Proposal: 2-4 Giffnock Avenue, Macquarie Park

Application No: SSD-79017211

In response to the City of Ryde Council comments dated 5 February 2026 under Stormwater comments section, we are pleased to provide you with our response below:

Integrated Water Management Plan

Drawing Title
STORMWATER CONCEPT PLAN
GROUND FLOOR

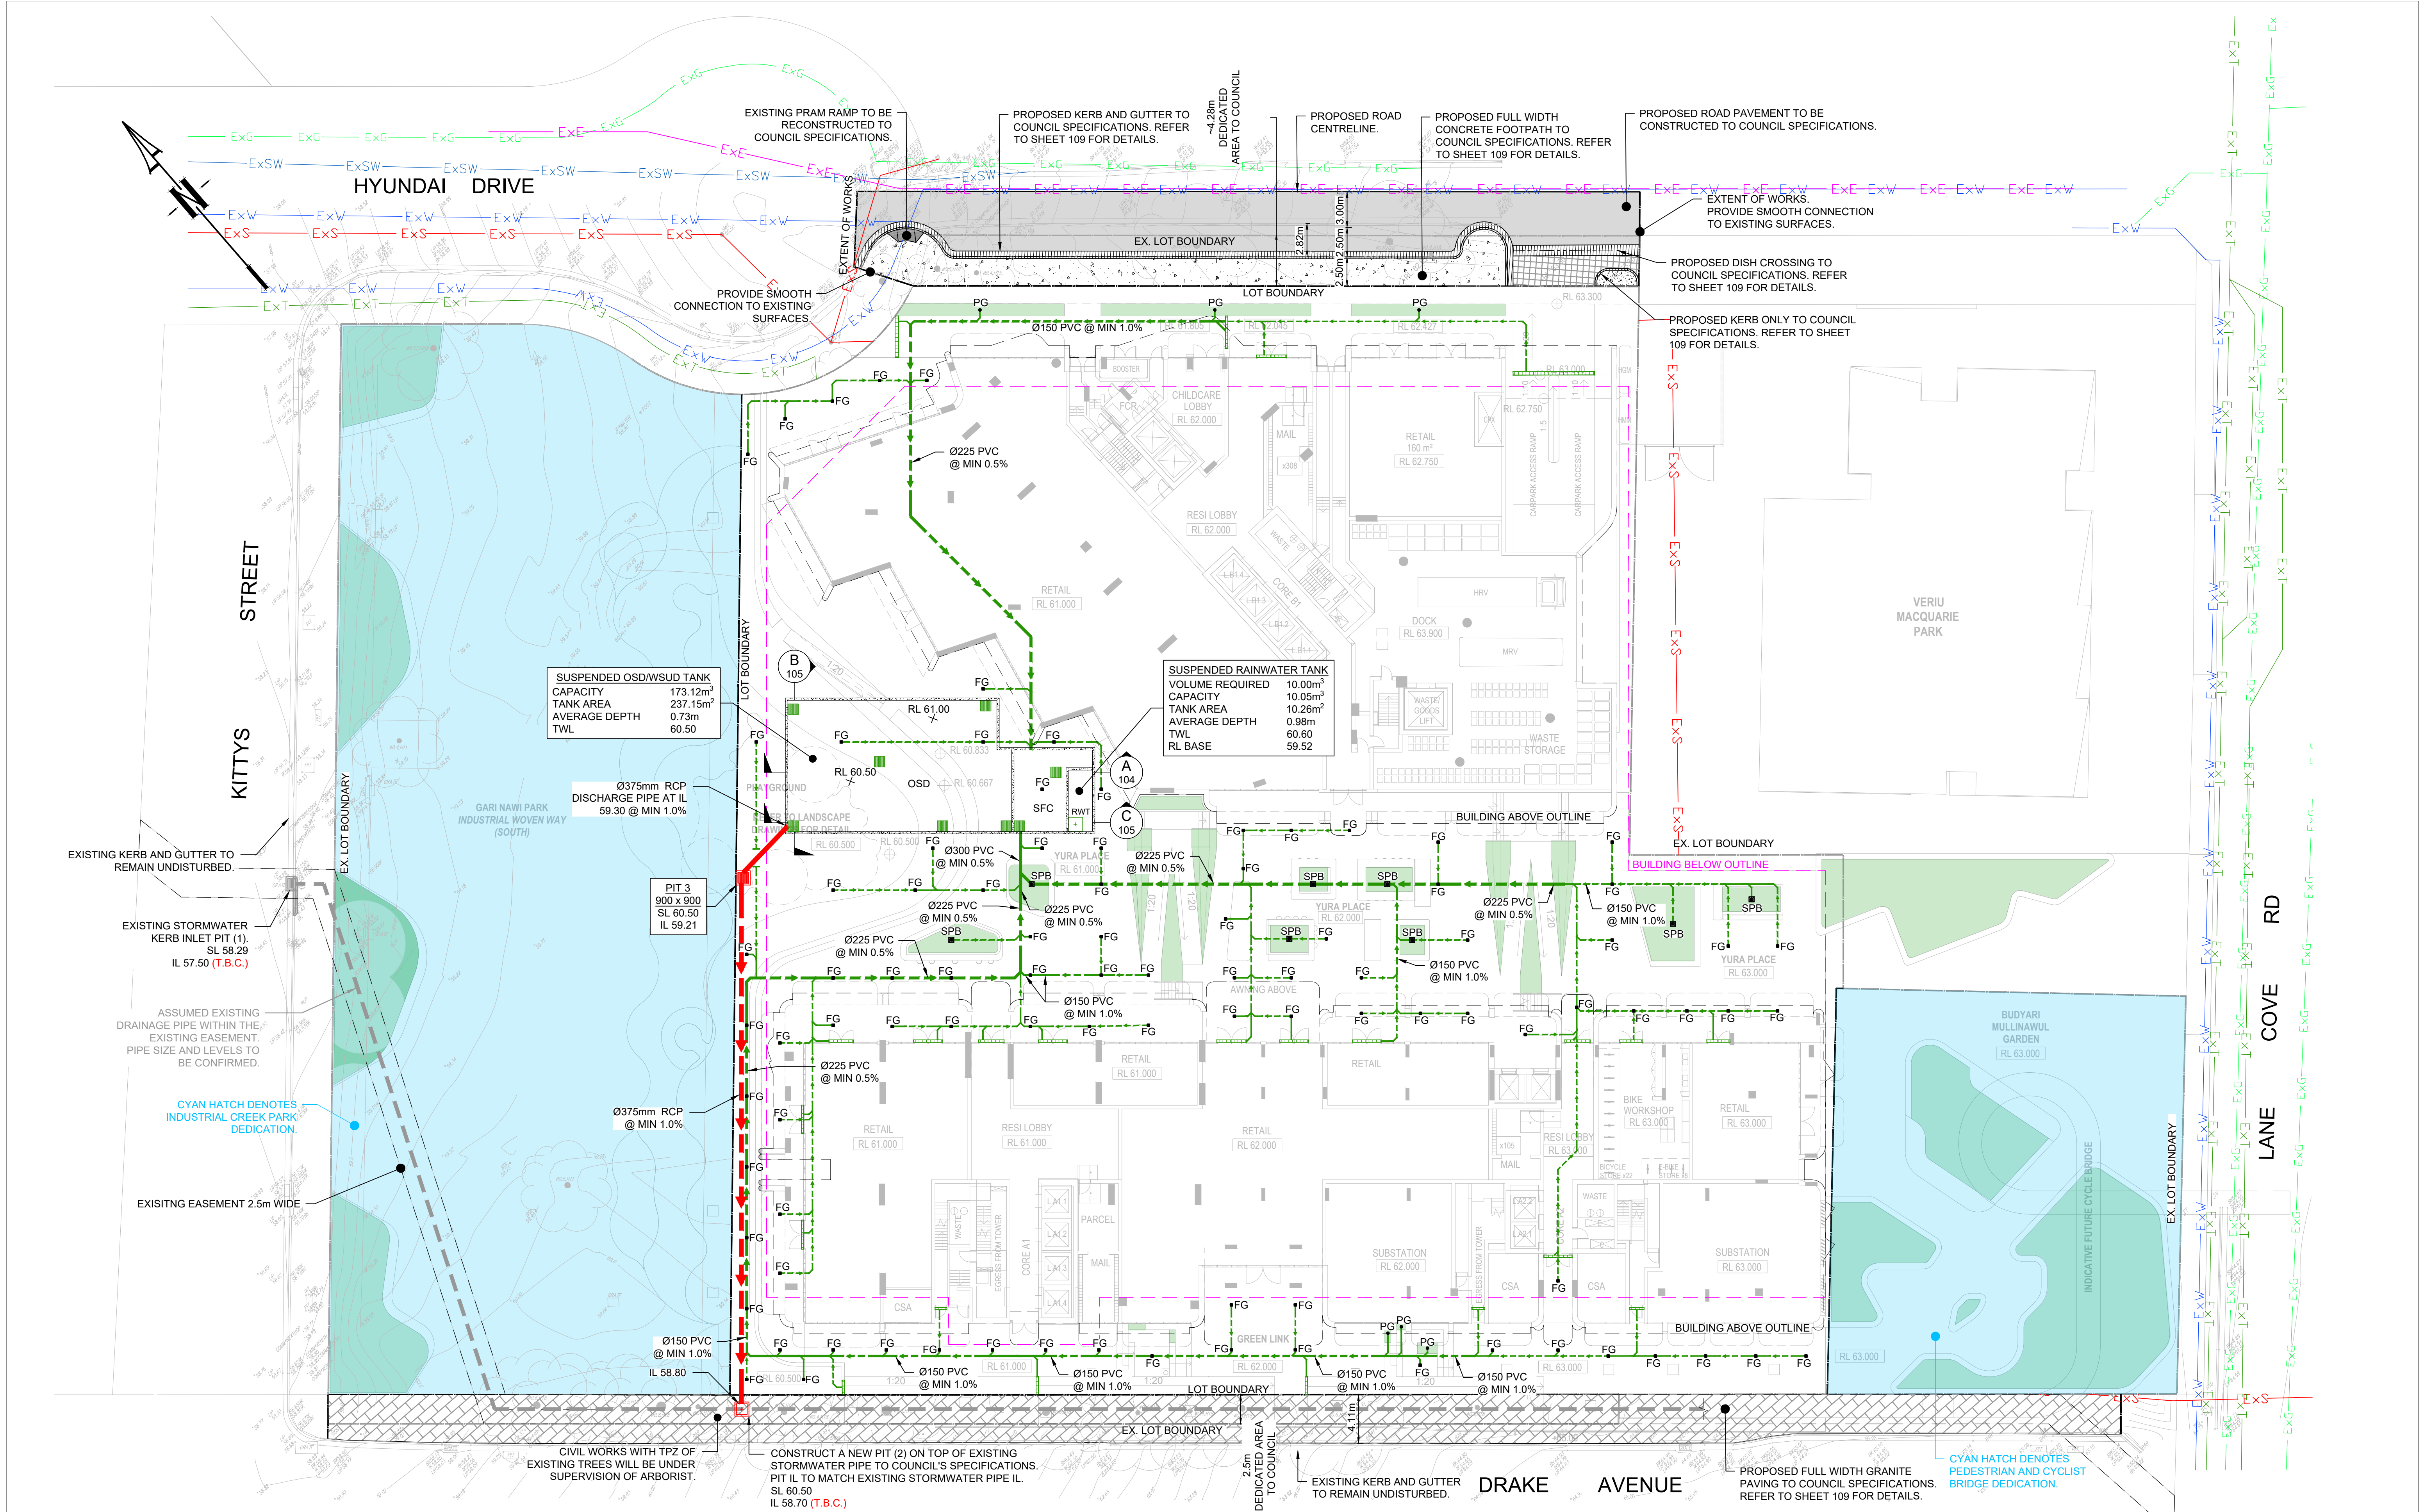
10.b.	Please update the Civil plans to indicate the new alignment of the kerb and gutter and stormwater infrastructure under the kerb and gutter. The plan is also to be updated to reflect:	This has been updated. Please refer to plans TEL24535.SW.DA - 2-4 Giffnock Avenue, Macquarie Park [G] sheet 101 for details.
	Kerb and gutter alignment to be shown.	This has been shown. Please refer to updated plans TEL24535.SW.DA - 2-4 Giffnock Avenue, Macquarie Park [G] sheet 101 for details.
	Please indicate cover depths and pipe classes under the footpath.	No new pipe is proposed in the updated set of drawings TEL24535.SW.DA - 2-4 Giffnock Avenue, Macquarie Park [G]
	Please provide a drainage network capacity assessment for the proposed connection(s) to Council's stormwater system. The assessment must confirm that the receiving network has adequate capacity to accommodate the development's discharge without causing surcharge or adverse downstream impacts.	Connection has been amended to become to the existing council easement – please refer to TEL24535.SW.DA - 2-4 Giffnock Avenue, Macquarie Park [G]

Where the assessment identifies insufficient capacity in the downstream system, the applicant must identify and propose any necessary upgrades to support the additional flows.	
	The outlet of the proposed pit to be 1% above the invert level of Council pit.	Connection has been amended – please refer to TEL24535.SW.DA - 2-4 Giffnock Avenue, Macquarie Park [G]
	Please include the outlet of the private junction pit higher than HGL backwater effect.	Connection has been amended – please refer to TEL24535.SW.DA - 2-4 Giffnock Avenue, Macquarie Park [G]
	HGL is to be clearly indicated on the plans.	Please refer to the Longitudinal Section on TEL24535.SW.DA - 2-4 Giffnock Avenue, Macquarie Park [G] – drawing 109
	Please clearly identify and annotate the ownership of all easements within your lot. Based on the available information, these easements service private developments and therefore must be maintained privately.	Connection has been amended to become to the existing council easement. This easement is clearly documented on the updated plans
